Docket Item #'s 5 & 6
BAR CASE # 2009-0088
#2009-0089

BAR Meeting
May 27, 2009

ISSUE: New Construction and Waiver of HVAC Screening Requirement

LOCATION: Phase One of James Bland Redevelopment at 808 Madison St (Project site: 918 N COLUMBUS STREET; 898 & 998 N ALFRED ST; 801, 813 & 808 MADISON ST & 100 FIRST STREET)

Figure 17. Proposed rear deck light fixture and garage door light fixture.

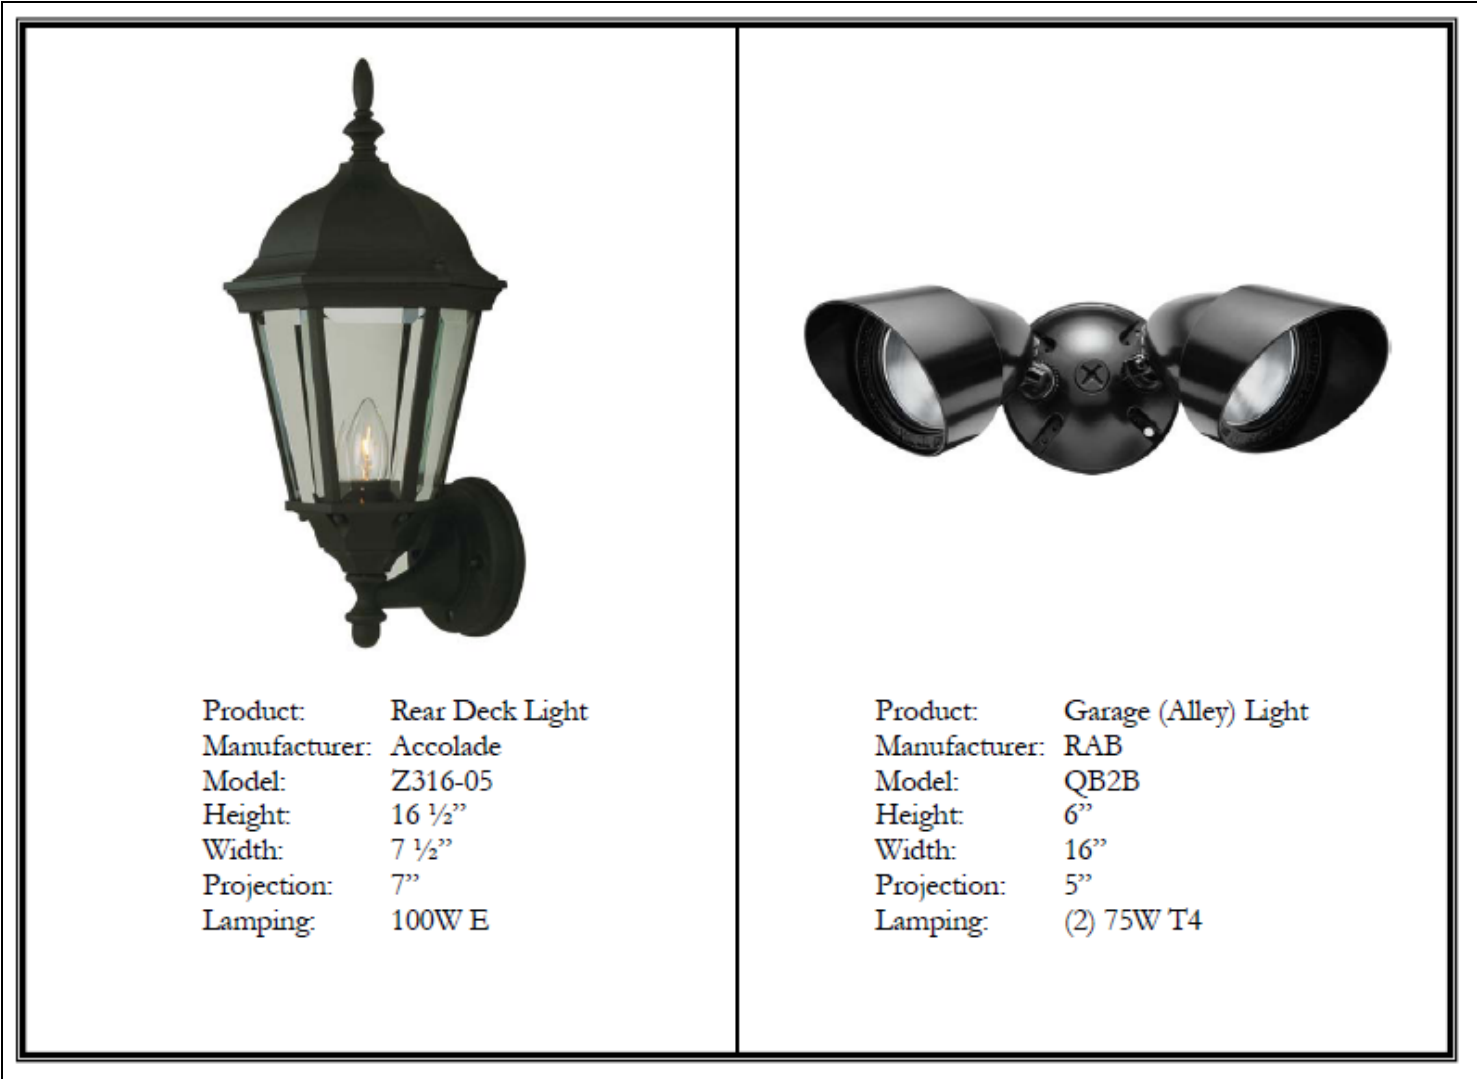
In general, the proposed lighting fixtures are acceptable and appropriate. Staff recognizes the need to select options for light fixtures that can be applied throughout the development. Staff supports the lighting fixture proposed for the top story loft levels which will provide light the upper level decks, while minimizing light spill over and nighttime visibility of the third and fourth story decks. Staff recommends that a less institutional and more appropriate light fixture be selected for the garage area rather than the more conventional spotlight that is proposed.

14. That the applicant work with Staff for final approval of a more appropriate light fixture over the garage.
15. That the applicant use traditional building materials, such as wood instead of synthetic materials, at the street-level, for items such as door surrounds, front doors, railings and the like, where they are most perceived by the public.

Figure 19. Proposed site plan elements: benches, bike racks, trash cans, and ganged mailbox units.

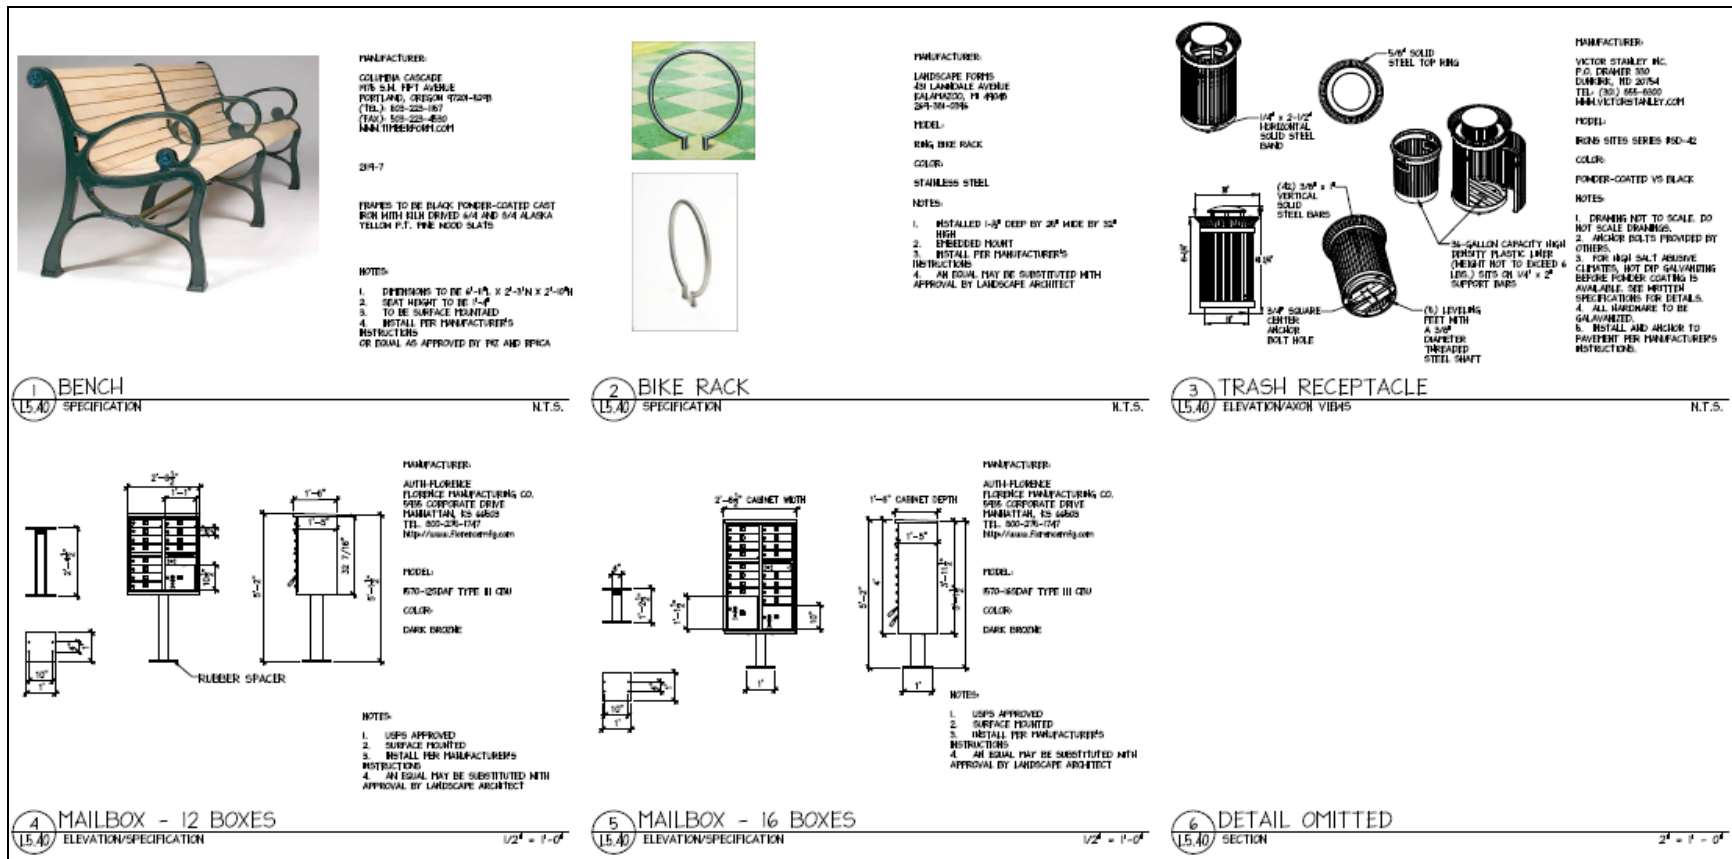
13. That the applicant eliminate the ganged mailboxes and provide mail slots through the door to be compatible with the character of the district. Should the only possible solution for mail delivery be ganged mailboxes, then the applicant should revise the location and design of the propose mailbox units to minimize their visibility and to be more compatible, with final approval by Staff.

13. That the applicant eliminate the ganged mailboxes and provide mail slots through the door to be compatible with the character of the district. Should the only possible solution for mail delivery be ganged mailboxes, then the applicant should revise the location and design of the propose mailbox units to minimize their visibility and to be more compatible, with final approval by Staff.

Figure 20. Wood fence (low and tall) and gate details.

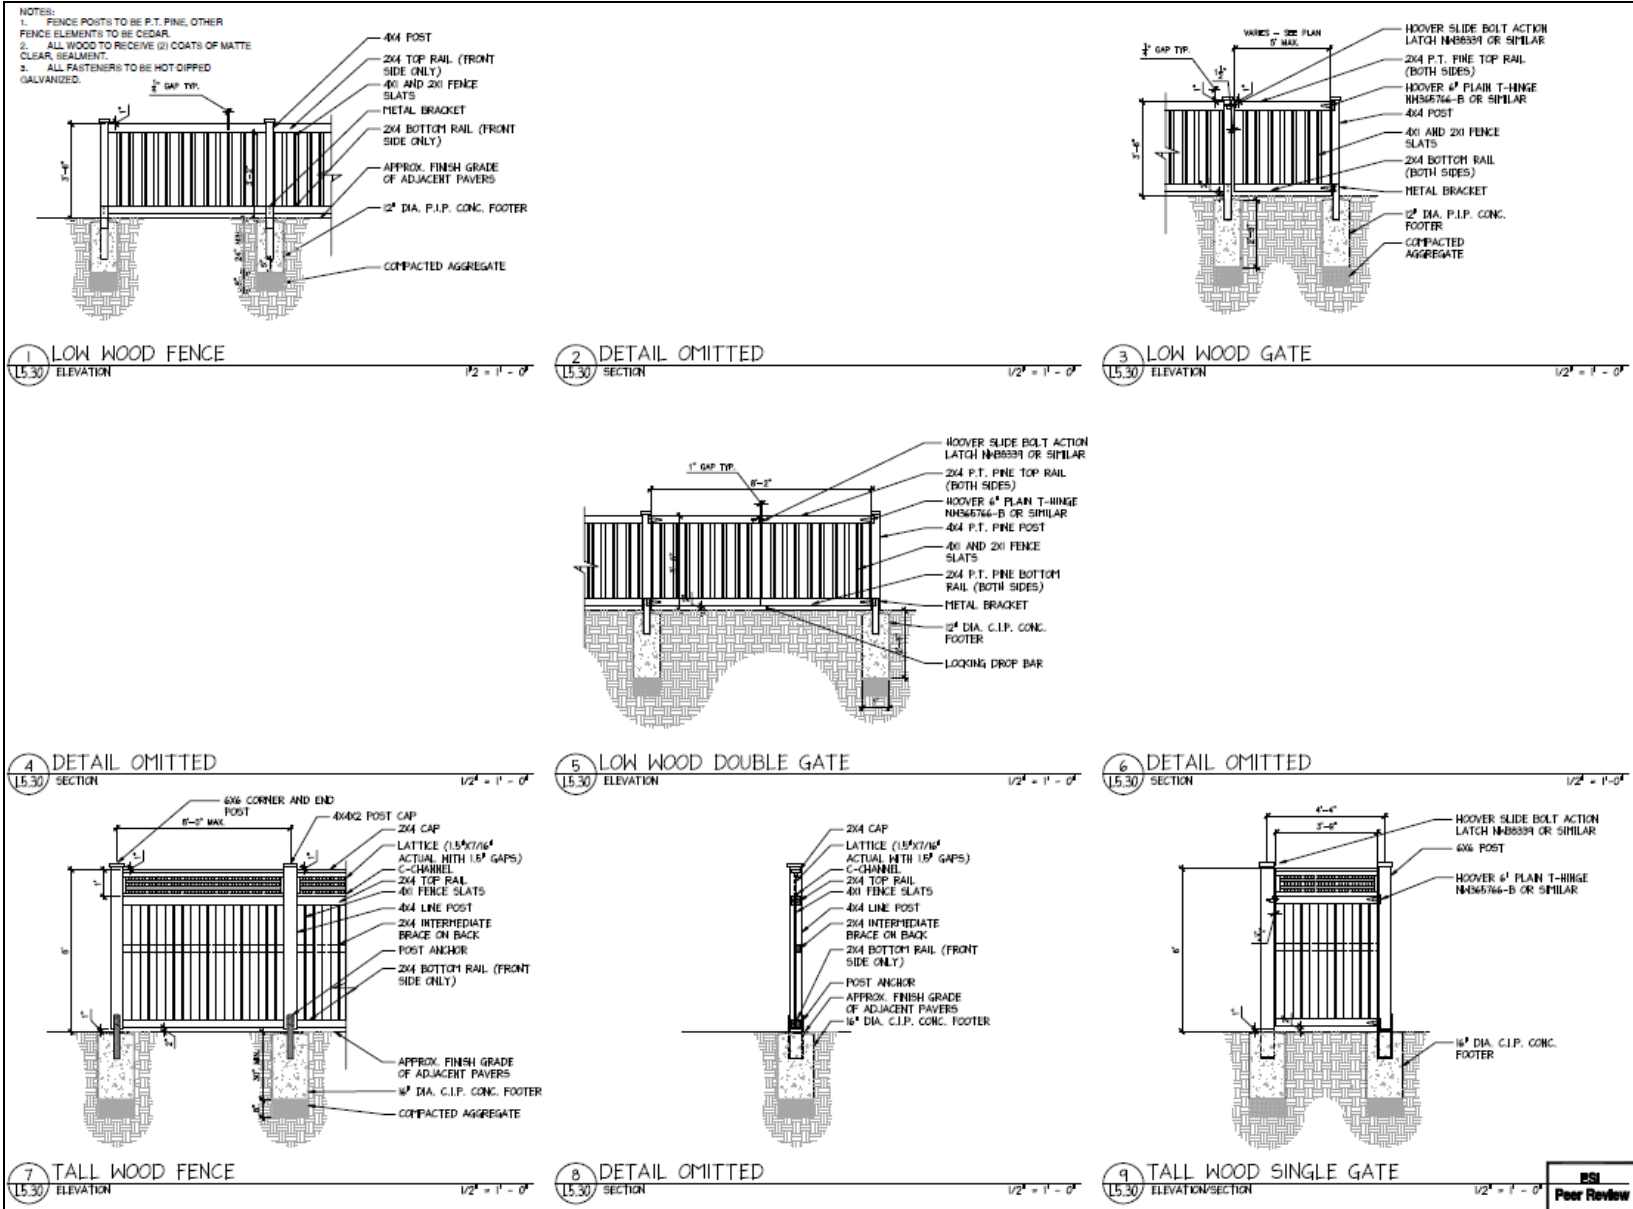
18. That the low fence meet the requirements of the zoning ordinance regarding being 50% open with final approval by Staff.

Figure 22. Side elevation showing visible loft element.

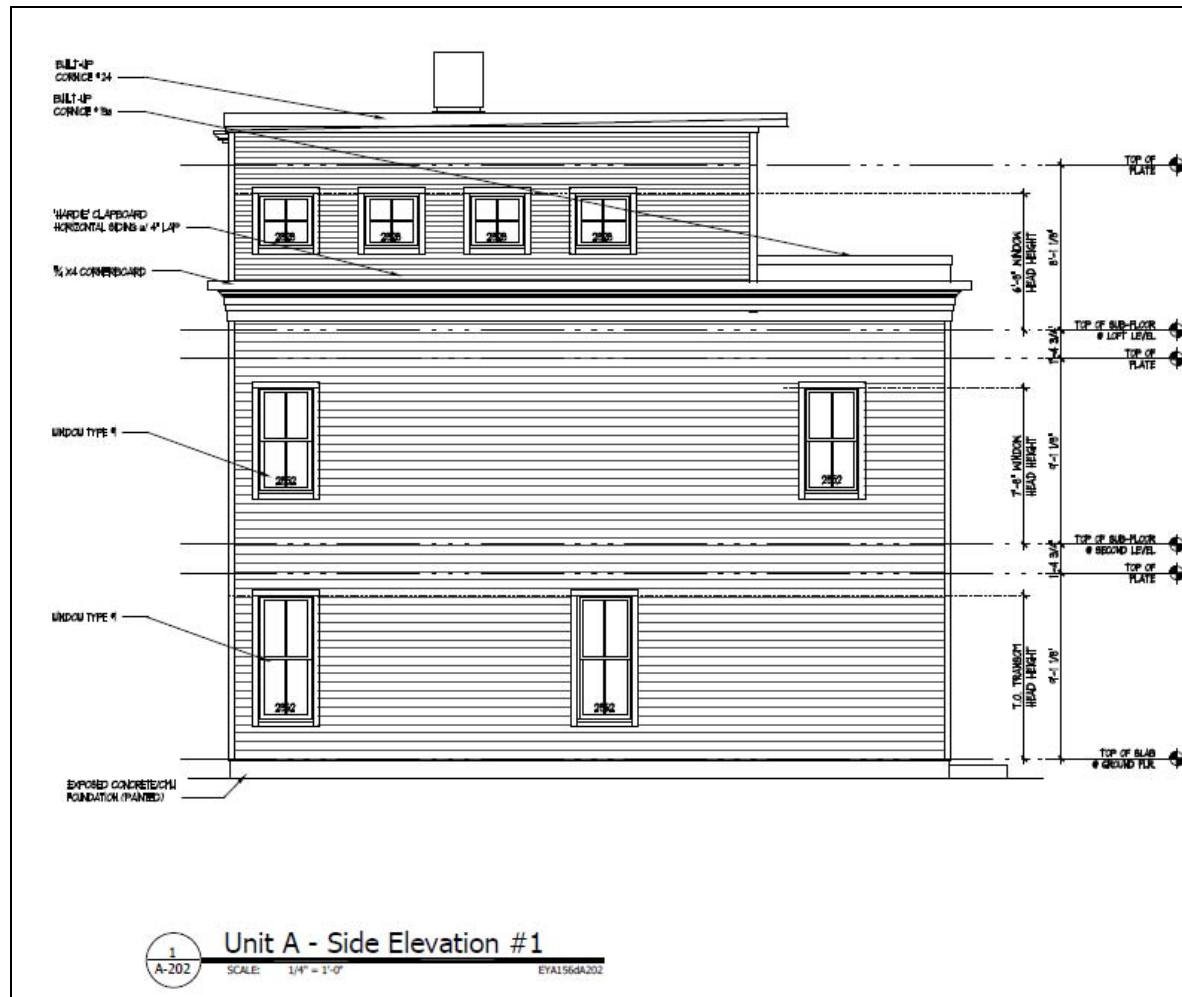
1. That the applicant revise the loft level at corner units so that it reads as a true monitor – more as a grid of windows with trim rather than a wall with punched windows.

1. That the applicant revise the loft level at corner units so that it reads as a true monitor – more as a grid of windows with trim rather than a wall with punched windows.

Figure 23. Example of units where rear fenestration should be refined (Sheet A-100).

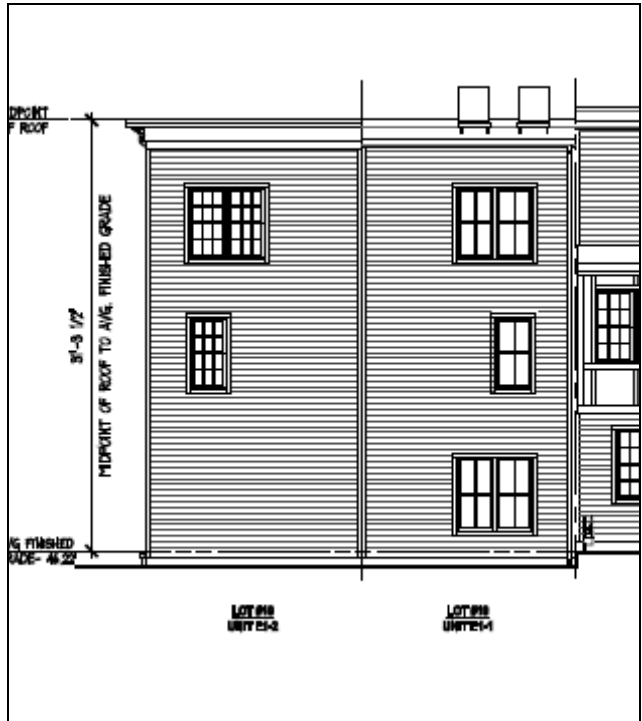
At the concept stage, a concern of the Board and Staff was the treatments of the side and rear elevations. The direction to the applicant was “Side and rear elevations should relate to their respective front elevations in regard to architecture, materials and color.” In Staff’s opinion, this issue has been resolved, noting that the *Design Guidelines* state that “side and rear walls which face open areas should be designed with as much attention to detail as the primary façade.” Staff finds that attention to materials, fenestration, and architectural details have been improved on the side and rear elevations, however, there are a few instances that must be reconsidered as the

plans are refined and finalized. Such details include door and window arrangement, particularly on the side and rear elevations where more windows are necessary, and alignment of doors and windows. Additionally, it should be noted that while most of the proposed brick townhouses are brick on all sides as recommended by Staff, the Washington-style townhouses are proposed with brick on the front but siding on the rear.

3. That the applicant work with Staff to restudy the number and placement of windows on the side and rear elevations of the proposed ARHA units to create a more compatible exterior fenestration.
